ADDENDUM #2

Renovation to the Old Detention Center for the Transylvania County Board of Elections Offices, Brevard, North Carolina

Addendum #2 **April 17, 2015**

SHEET ADD-2A

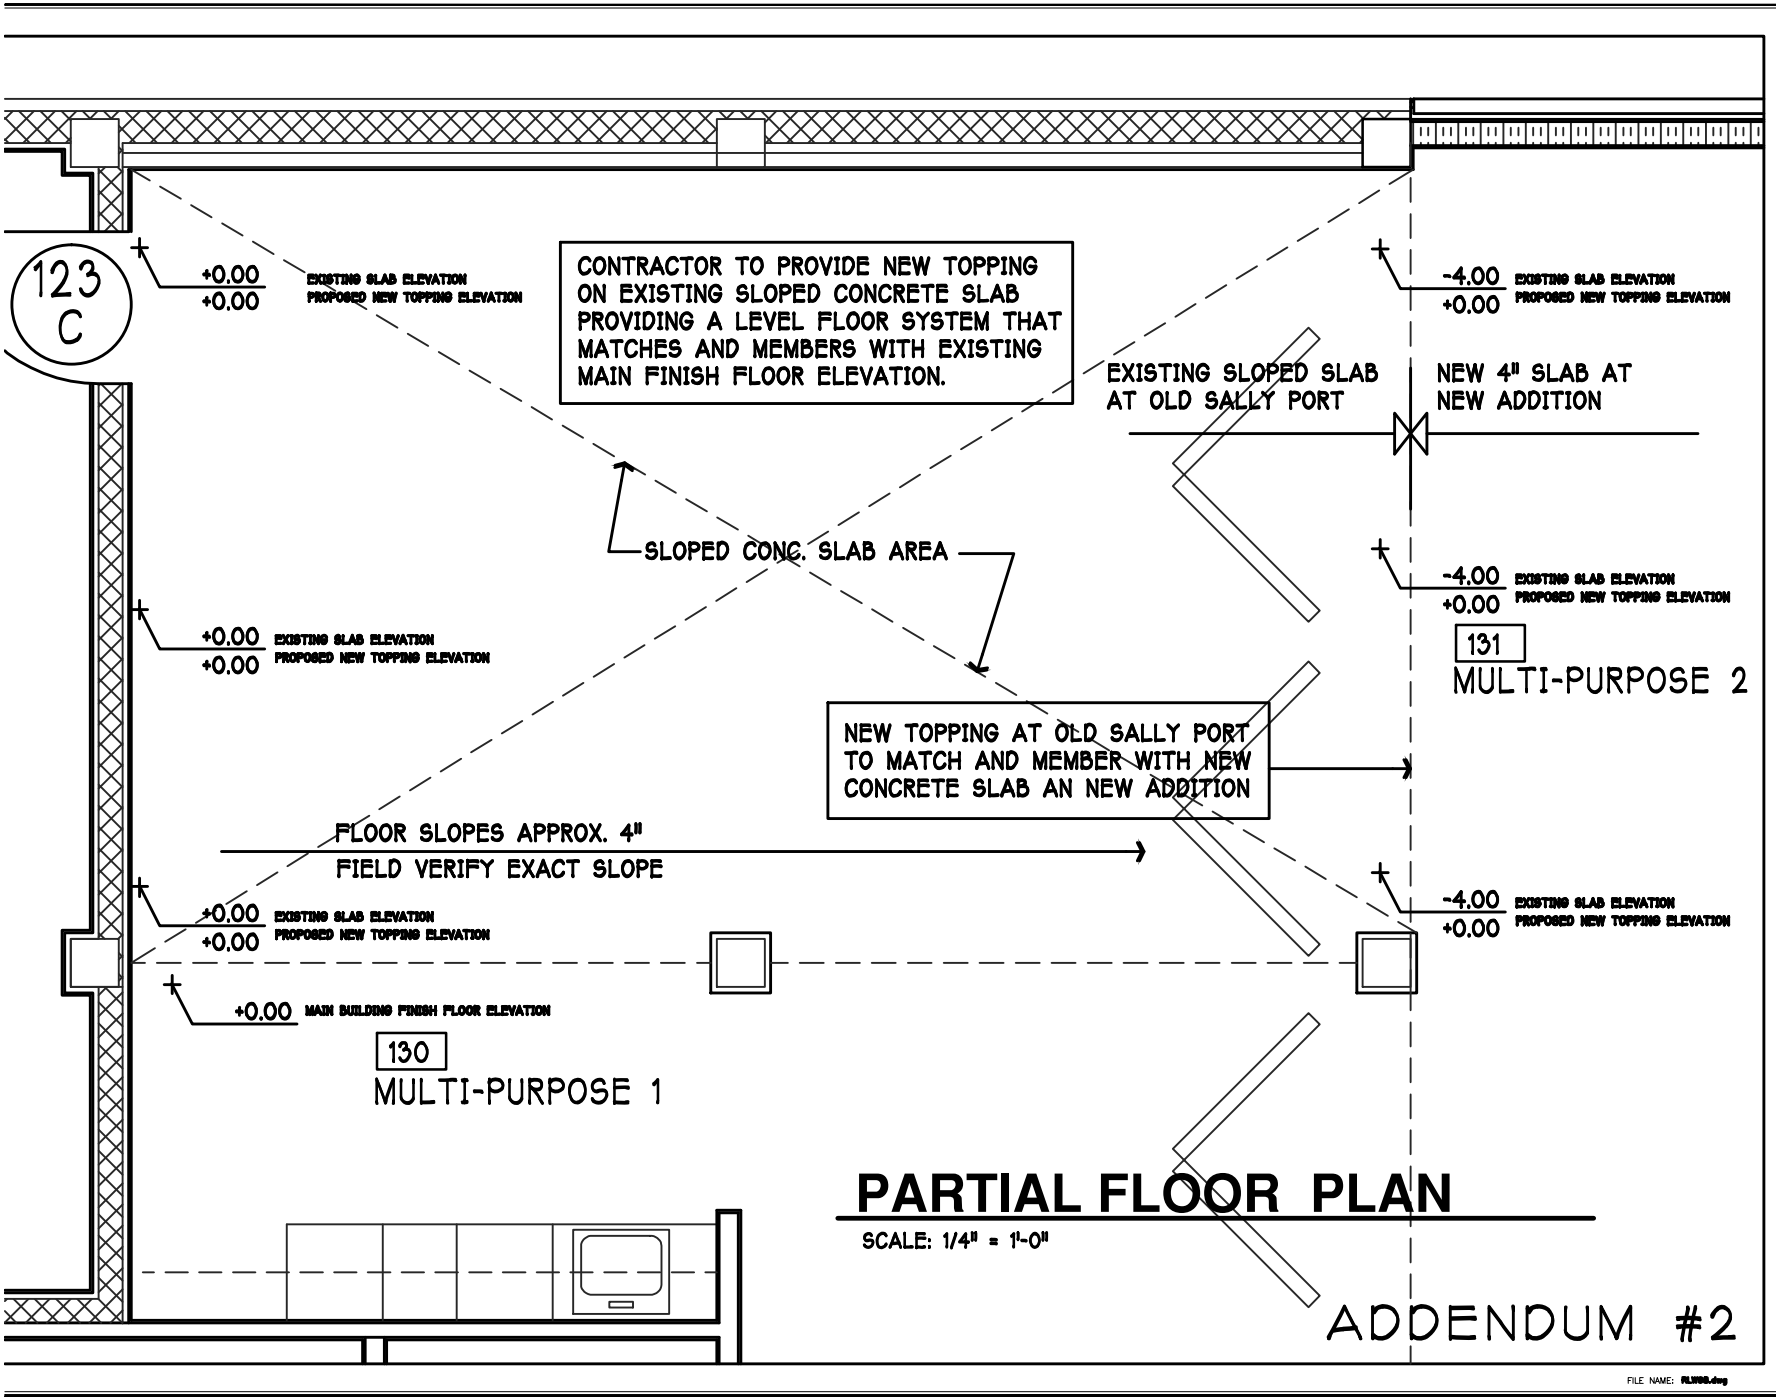
A. A portion of the existing floor of Multi-Purpose 1 – Space #130 slopes as indicated on the attached Partial Floor Plan - Sheet ADD-2A. This slope is to have a new topping installed on the existing concrete slab. The existing sloping slab area is to be prepared using shot blasting to remove all finishes, curing compounds, etc. in order to provide a structural bond between remaining concrete slab and new topping material. Installation is to be in strict accordance with the topping manufacturer's recommendation and requirements (see attached ARDEX document dated April 9, 2015 and all materials and installations must be coordinated with and approved by the floor finish manufactures (see finish schedule and project manual for floor finish information).
